# Certificate of Appropriateness

Upon appeal to the Board of Supervisors of Loudoun County ("Board") pursuant to §6-1909 of the Loudoun County Zoning Ordinance, and pursuant to a Settlement Agreement between the Board and Mrs. Milari Madison resolving several legal matters related thereto (Case Nos. 62862, 63609 and 64978), the parties agree to modify Condition #25 of the Certificate of Appropriateness (2010-0002) ("CAPP") previously approved by the Loudoun County Historic District Review Committee on June 14, 2010 and further agree that all other conditions in the June 14, 2010 CAPP shall remain in effect and enforceable. Therefore, the Board hereby approves this Certificate of Appropriateness (2010-0002), issued to Mrs. Milari Madison for the property identified by Loudoun County as MCPI# 304-46-4671 and located within the Waterford Historic and Cultural Conservation District for the construction of a new residence. The approved application consists of revised elevations, detailed architectural feature drawings, and additional materials list dated and submitted May 17, 2010; materials list dated and submitted April 23, 2010; plat dated and submitted March 19, 2010; and incorpora

FRONT ELEVATION  
SCALE: AS SHOWN  
3-11-11

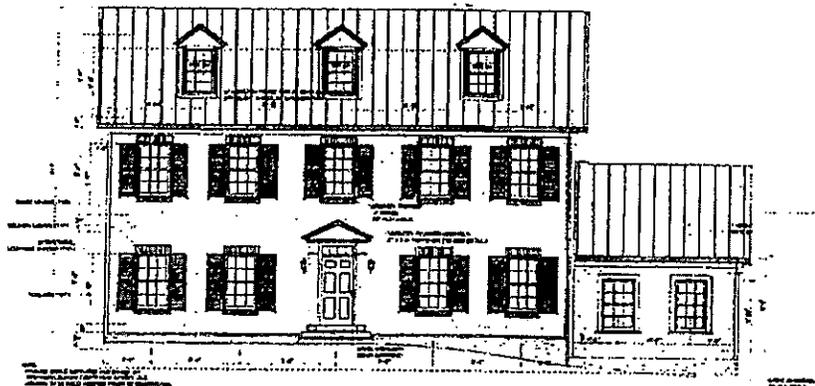
- 1.) The exposed foundation heights match those depicted on the plans dated May 17, 2010. The foundation will be constructed without a water table.
- 2.) The main block on all sides is constructed of brick in either Flemish or common (American) bond, not running bond as depicted in the elevations. To meet the Guidelines the brick must be roughly 7 ½ inches by 3 ½ inches by 2 inches, the bricks should replicate the size, texture, and color of locally fired bricks used in the construction of historic buildings in the Waterford Historic District. Wire cut brick and artificially or chemically treated brick will not be used. The mortar should match the texture and color of historic mortar used in Waterford. The joint size and tooling should have a narrow concave joint as depicted on page 122 of the Waterford Guidelines.

- 3.) The brick chimney must be constructed in running bond with a simple corbelled top to meet the Guidelines similar to Photo 3 on page 2 in the Staff Report Addendum dated May 17, 2010. The drawings do not currently reflect the described corbelling. The chimney brick and mortar should match the main block.

- 5.) The windows in the front and side elevations of the main block will have louvered shutters. The shutters must be made of painted wood, mounted on hinges, and be sized to the related window openings to meet the Guidelines.

- 7.) The dormers will be 7 feet in height, sheathed with a standing seam metal roof, and sided with horizontal cementitious siding matching the ell and bump out. The dormer siding currently depicts diagonal siding, which does not meet the Guidelines.

- 9.) The junction of the brick main block with the cementitious siding clad masses should be finished with a narrow trim board at the edge of the cementitious siding. This is currently not reflected in the drawings.

- 12.) All windows and the front door of the main brick block will have flat trapezoidal jack arches across the top constructed following traditional building techniques similar to photos 1 and 2 on page 2 in the Staff Report Addendum dated May 17, 2010. Attic windows in the brick main block will have a flat arch constructed of vertical header bricks. Jack arches as depicted in the elevations do not meet the Guidelines.

- 13.) The front door surround will be constructed in accordance with front elevation drawing with a full pediment and all depicted details as submitted May 17, 2010, not a broken pediment as depicted on the detail of the surround submitted the same day.

- 24.) No rake board will be constructed on the side elevations of the brick main block.
- 25.) A one-story west wing is approved, with no possibility to add a second floor, and that the west elevation of the main block shall match the proposed west elevation drawing attached hereto. The applicant shall have the option of no centered window on the second floor or a centered window on the second floor, shorter in height than on the east elevation.
